TECHNICAL BULLETIN

MODEL/DERIVATIVE:
Freelander

Bulletin N°: 0068
CDS. ref: L8640bu
Issue: 1
Date: 02.05.01

SOFTBACK SEAMS SPLITTING IN 'E' POST AREA.

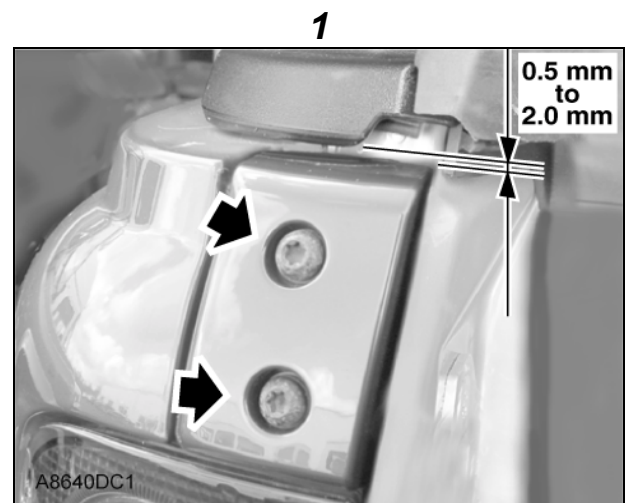
The *minimum* acceptable gap is 0.5mm and the *maximum* acceptable gap is 2.0mm

Vehicles without roof bars.

1. Release the Softback fasteners to reveal the lower body finisher.
2. Loosen the two 'E' post finisher Torx bolts, (arrowed in illustration 1).
3. Push the 'E' post finisher downwards and outboard so that it locates fully onto the body and maintains a minimum gap to the body side. The gap achieved between the 'E' post finisher and the lower body finisher must be between 0.5mm and 2.0mm, (refer to illustration 1).
4. Tighten the two Torx bolts to 4Nm.

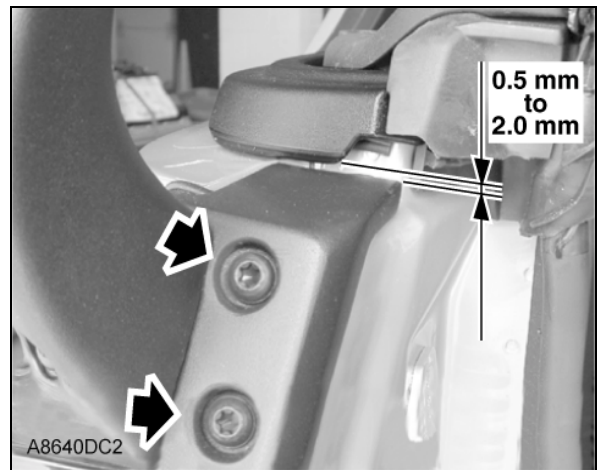
Vehicles with roof bars.

1. Release the Softback fasteners to reveal the lower body finisher.
2. Loosen the two roof bar adaptor Torx bolts, (arrowed in illustration 2).
3. Push the roof bar adaptor downwards and outboard so that it locates fully onto the body and maintains a minimum gap to the body side. The gap achieved between the roof bar adaptor and the lower body finisher must be between 0.5mm and 2.0mm, (refer to illustration 2).
4. Tighten the two Torx bolts to 22Nm.
